CURRENT EXISTING 2ND BUILDING DEPARTMENT SUBMITTAL SET

ROUND BARN VILLAGE

SANTA ROSA, CA

BUILDING TYPE 100 | Slab Edge & 1st Floor Plan Composite

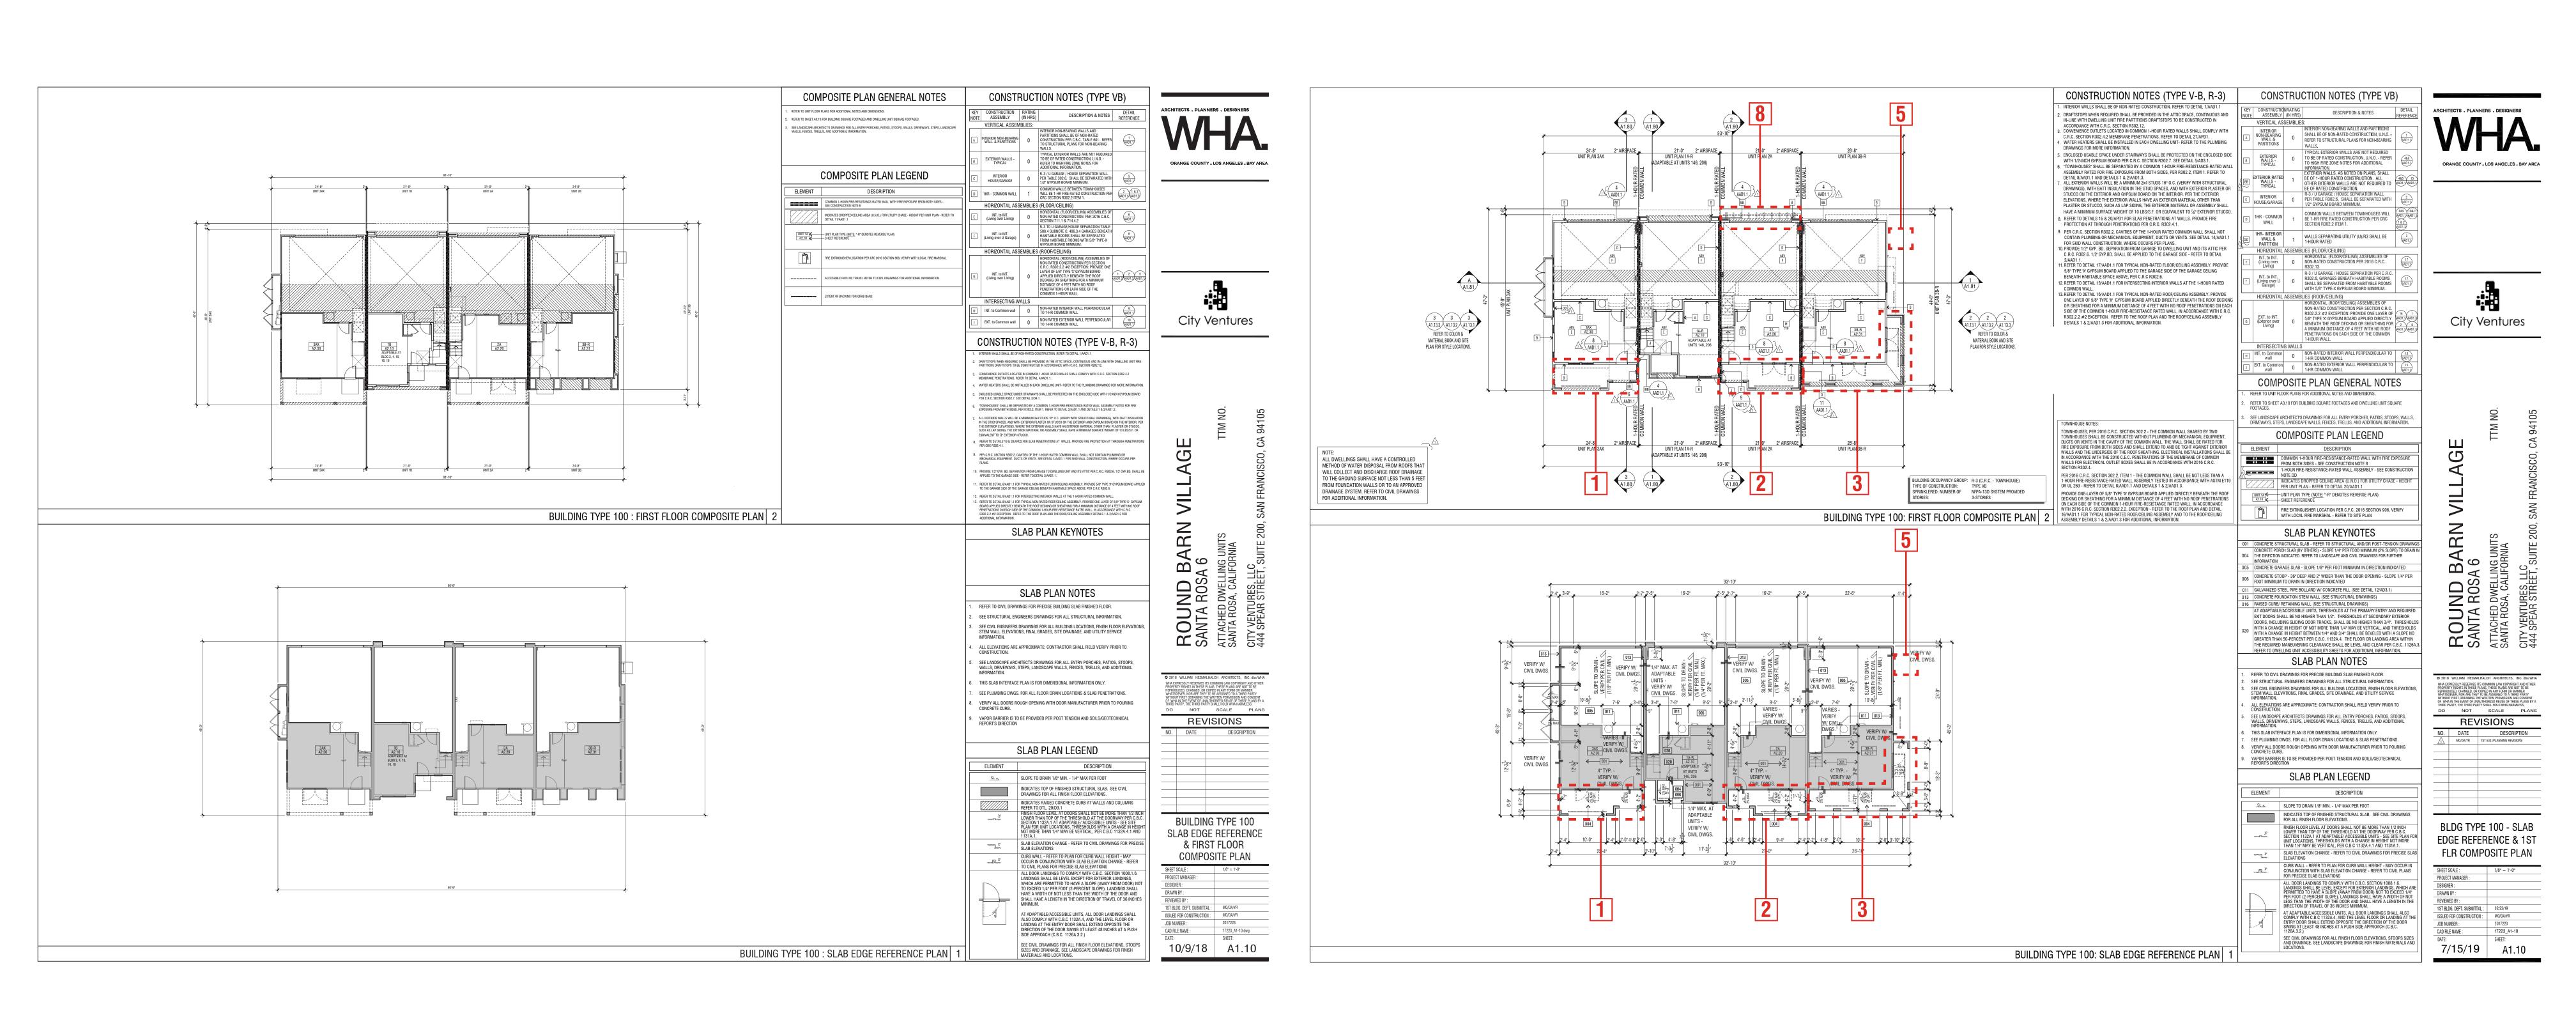
- 1 Unit 3A Added Covered Deck | Created Double Gable | Reconfigured Windows | Removed Awnings Above Windows | Removed / Replaced Horizontal Siding with Boards & Batts.
- 2 Unit 2A Added Covered Deck | Created Double Gable | Reconfigured Windows | Removed Awnings Above Windows | Removed / Replaced Horizontal Siding with Boards & Batts.
- 3 Unit 3B Added Wrap Around Deck / Reconfigured Porch | Added 3050 Window | Added Awning Above Deck Door and Windows at second level
- 4 Added Gable/Sloped Roof
- 5 Removed Ladder
- 6 Revised Second Floor Massing at Kitchen
- 7 Added Awning
- 8 Added Trellis at Unit 2A, Typ.

BUILDING TYPE 100 | 2nd & 3rd Floor Plan Composite

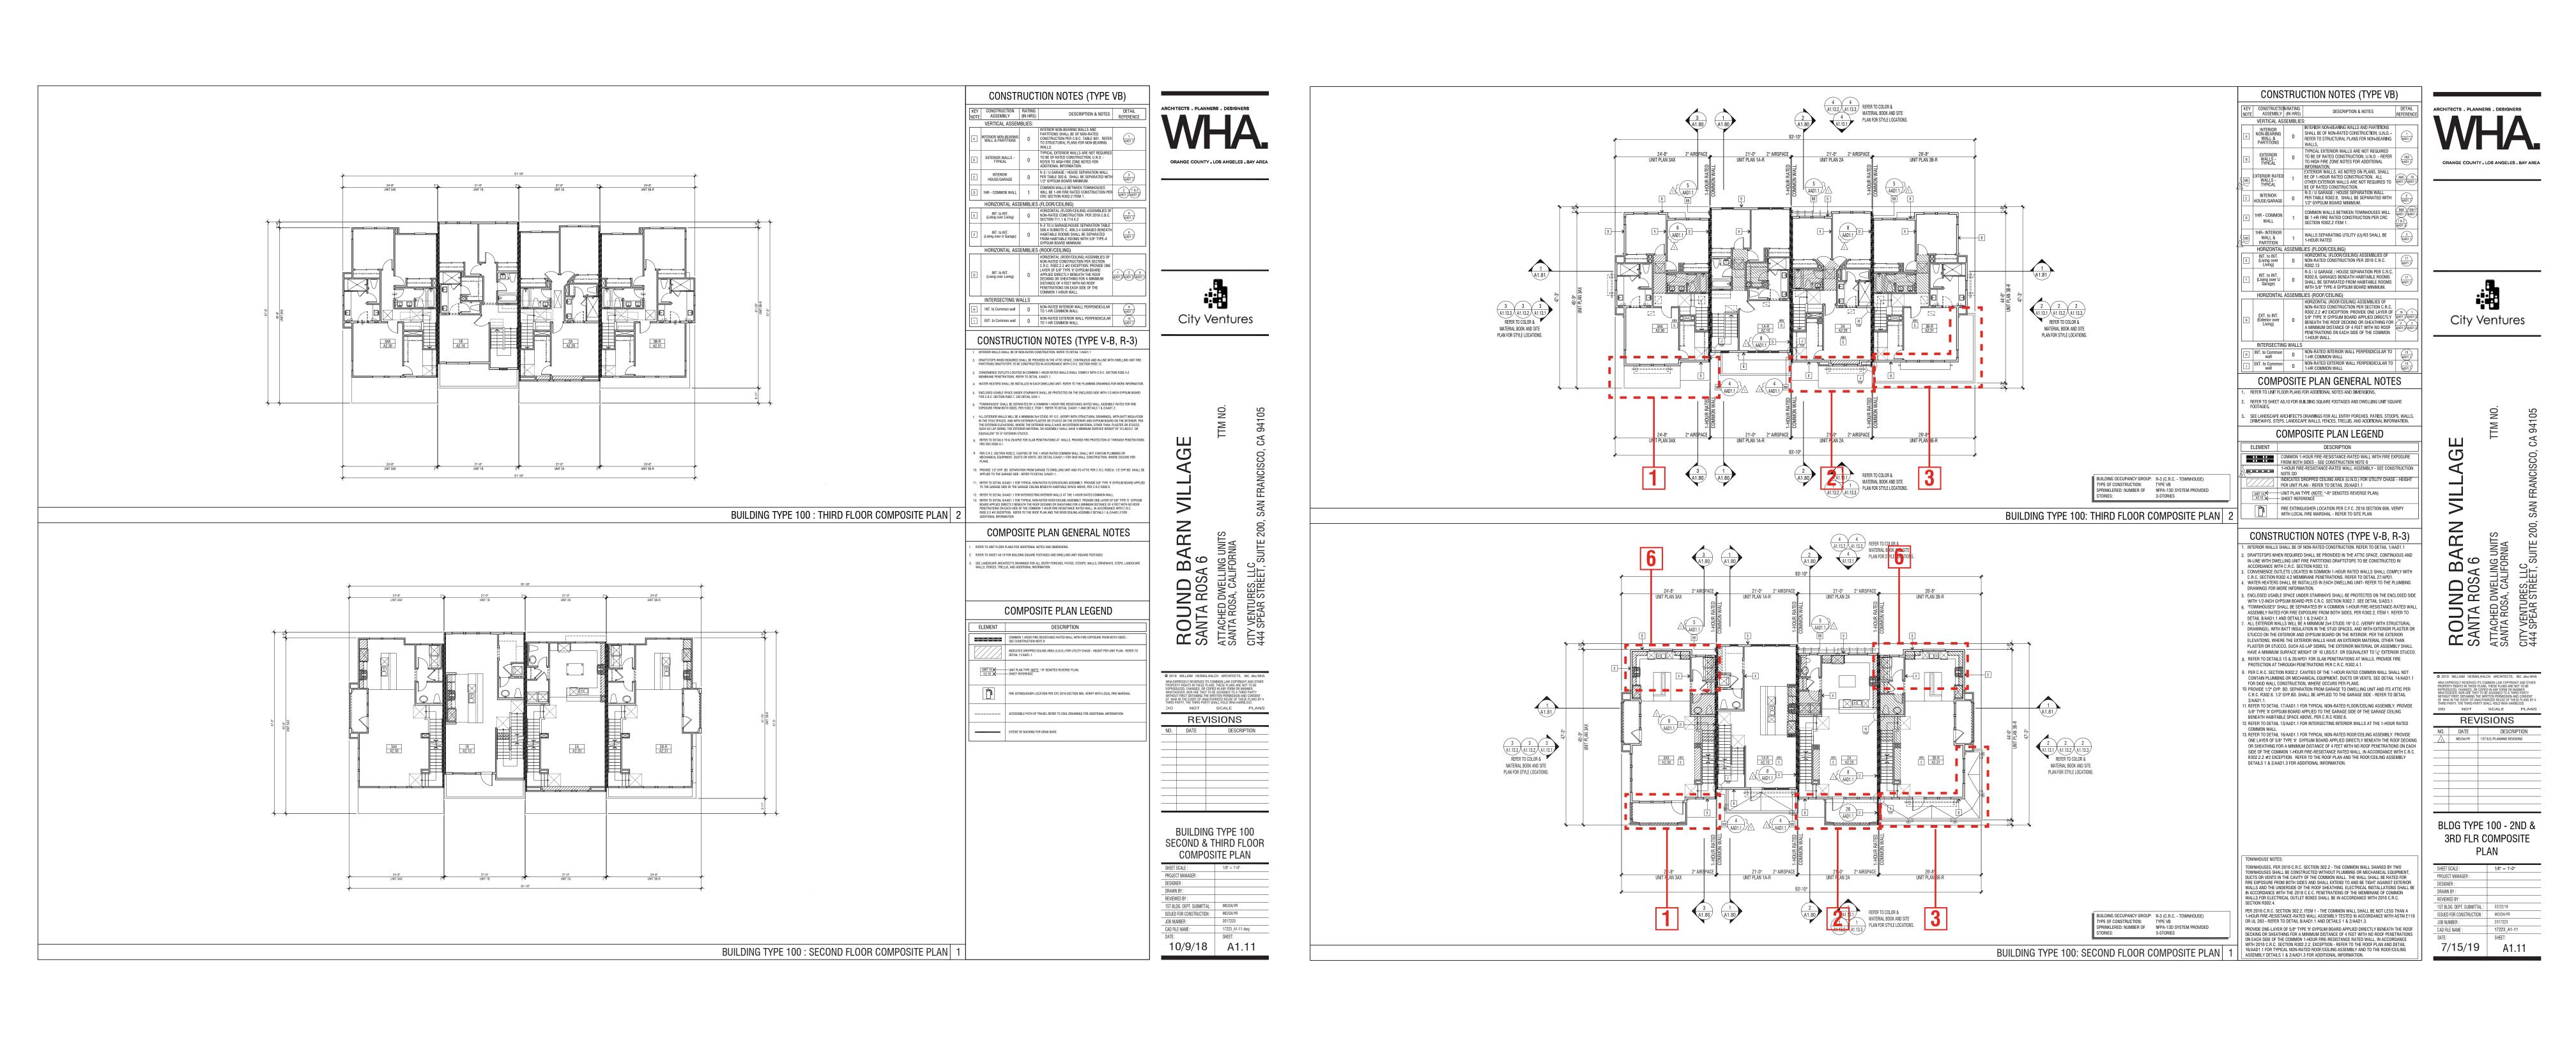
- 1 Unit 3A Added Covered Deck | Created Double Gable | Reconfigured Windows | Removed Awnings Above Windows | Removed / Replaced Horizontal Siding with Boards & Batts.
- 2 Unit 2A Added Covered Deck | Created Double Gable | Reconfigured Windows | Removed Awnings Above Windows | Removed / Replaced Horizontal Siding with Boards & Batts.
- 3 Unit 3B Added Wrap Around Deck / Reconfigured Porch | Added 3050 Window | Added Awning Above Deck Door and Windows at second level
- 4 Added Gable/Sloped Roof
- 5 Removed Ladder
- 6 Revised Second Floor Massing at Kitchen
- 7 Added Awning
- 8 Added Trellis at Unit 2A, Typ.
